# REGIONAL REVIEW FINDING

**ARC REVIEW CODE:** R1604061

**Name of Proposal:** Decatur Crossing Phase III

**SUBJECT:** **Transportation Division Review of DRI # 2558**

DESCRIPTION		DATE		BY	
DRAWN BY		CHECKED			
SCA					
DATE		3/1/2016			
		SHEET TITLE			
		SITE PLAN			
SHEET NUMBER		SP-70b			
HGA JOB No. 2012-1

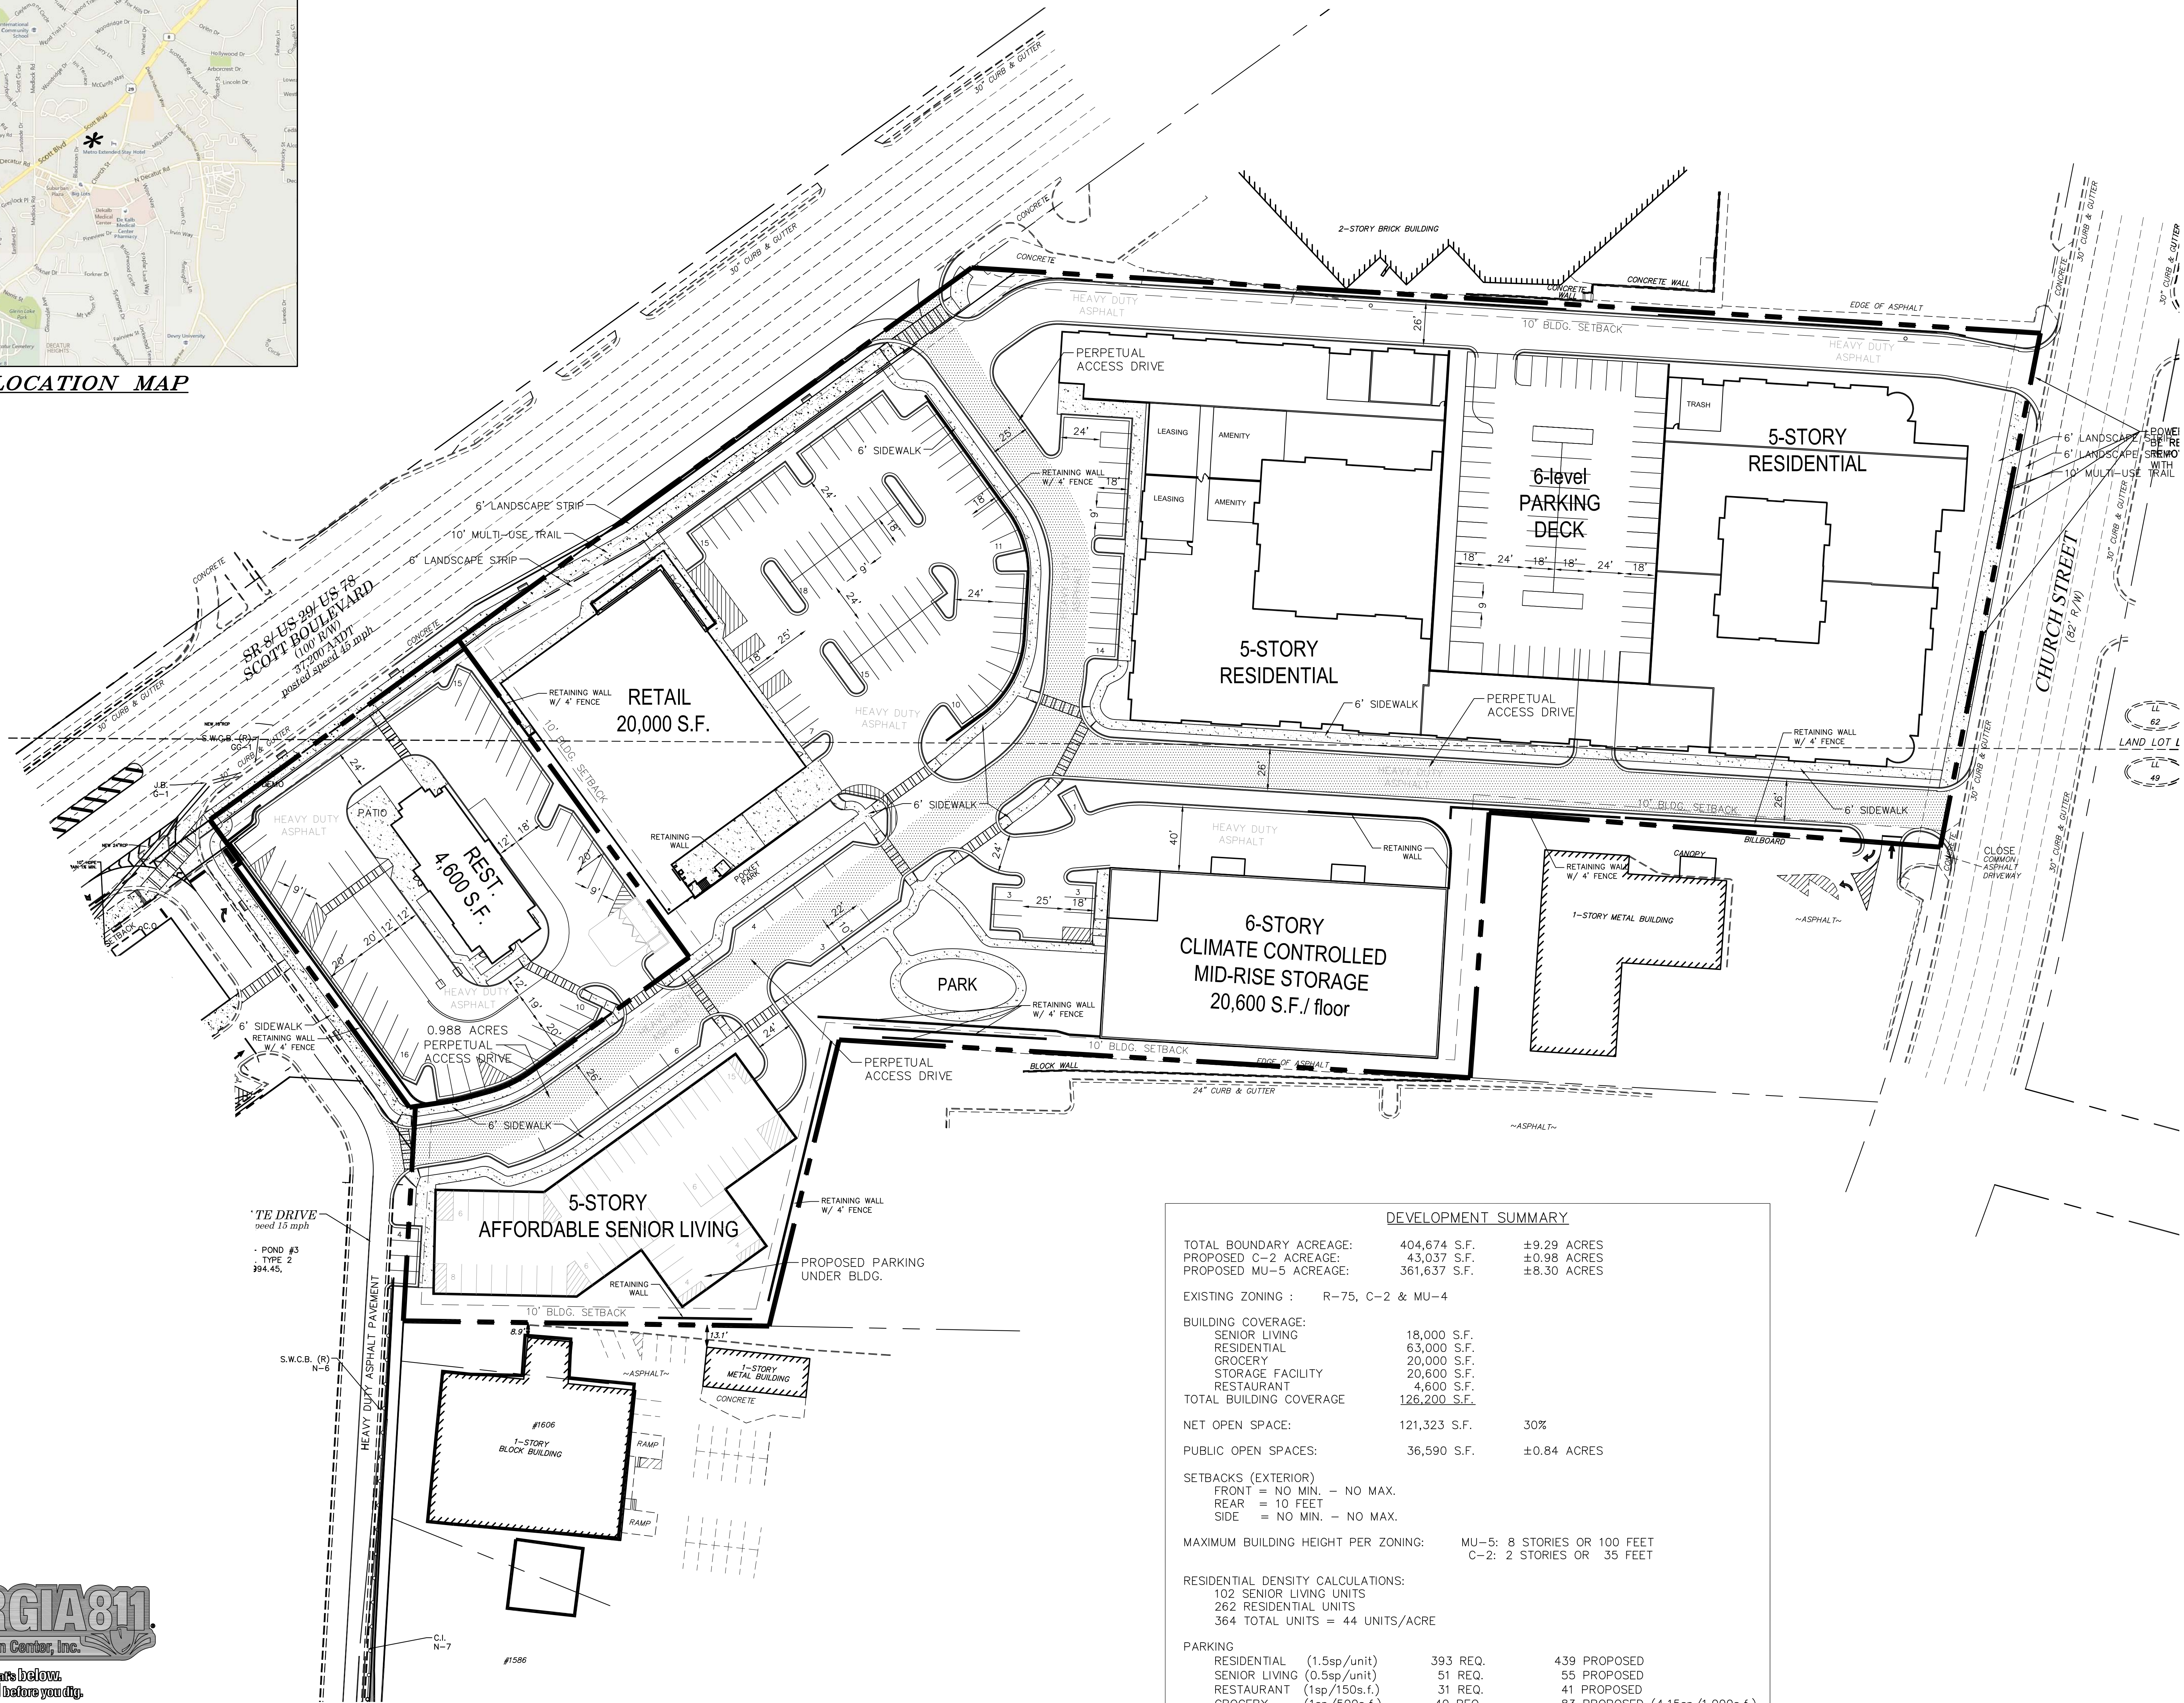
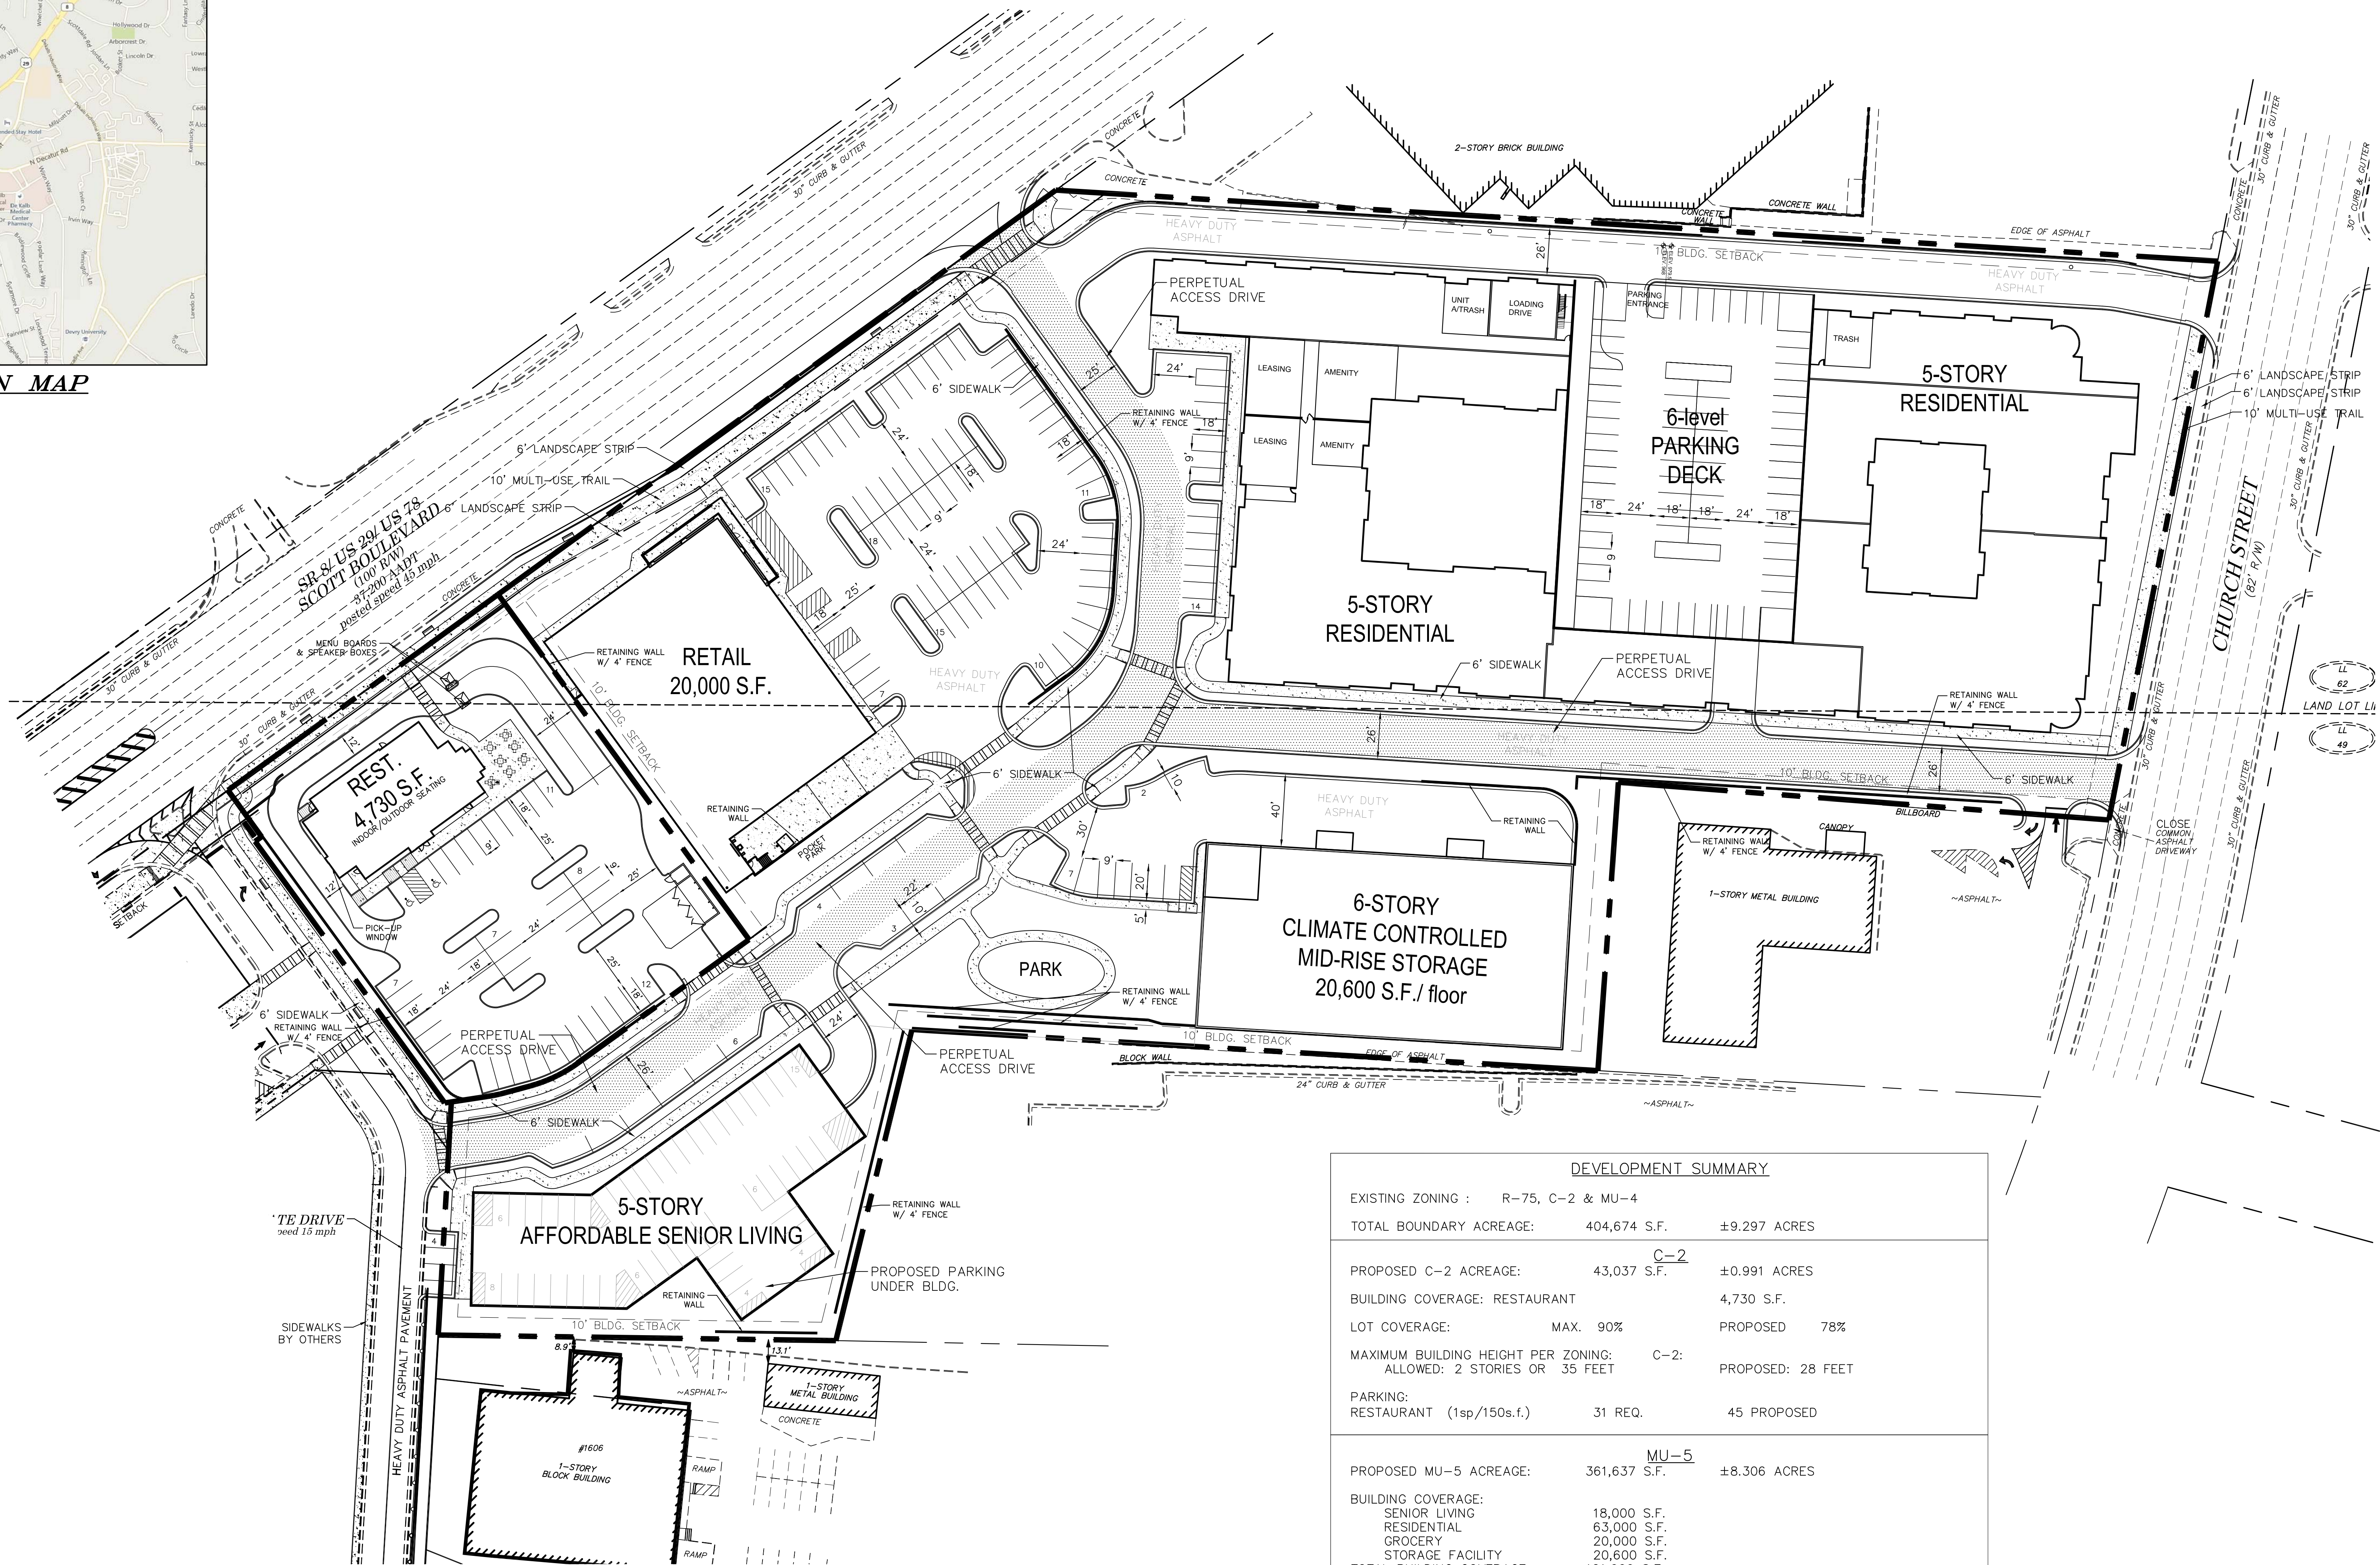
1. Increase sidewalk widths internal to the development from 6' to 8'
2. Provide covered bicycle parking in convenient locations and show on the site plan.

3. The new development is likely to make left turns out of Tuxworth Circle more difficult and possibly dangerous. Consider realigning the entrance to the development with Tuxworth Circle driveway to control all turning movements, or investigate other solutions to allow for safe left turns for residents of the Tuxworth Springs complex.

4. Consider redesign/re-orientation of the free-standing restaurant and retail buildings along the Scott Blvd to front Scott Blvd, remove driveway between building and sidewalk along Scott Blvd, and locate parking in the rear of the buildings and reduce parking if possible to provide a more pedestrian-friendly design, consistent with the Region's Plan, the Medline LCI Plan and County's Healthy Plan and “Live

5. Create safe bicycle and pedestrian access on the service alley along the northern boundary of the development, connecting Scott Blvd and Church St. This can be done by creating a separated facility, or through traffic calming and “shared street” design treatments, e.g. use of special paving that provide visual and audio cues to reduce speed.

6. To mitigate the induced traffic from this development, and the lack of transit (only one existing bus route), provide reserved spaces for zip car and drop-off lanes/spaces for Uber/Lyft/Taxis and Cliff Shuttle.

7. Align the internal (unnamed) southwest-northeast street from Phase 2 with internal (unnamed) street on Phase 3 to remove “dogleg” at the Phase 3 entrance. The current configuration could cause traffic to back up onto Scott Blvd.

8. Shorten curb radii on the deceleration lanes on Scott Blvd to reduce the speeds of vehicles turning right into the development as they cut across the sidewalk/path crosswalk. Paint a stop bar on the decel lane preceding the crosswalk, and include “Stop Here for Pedestrians” sign at both Scott Blvd entrances (See R1-5c in the Manual of Uniform Traffic Control Devices).
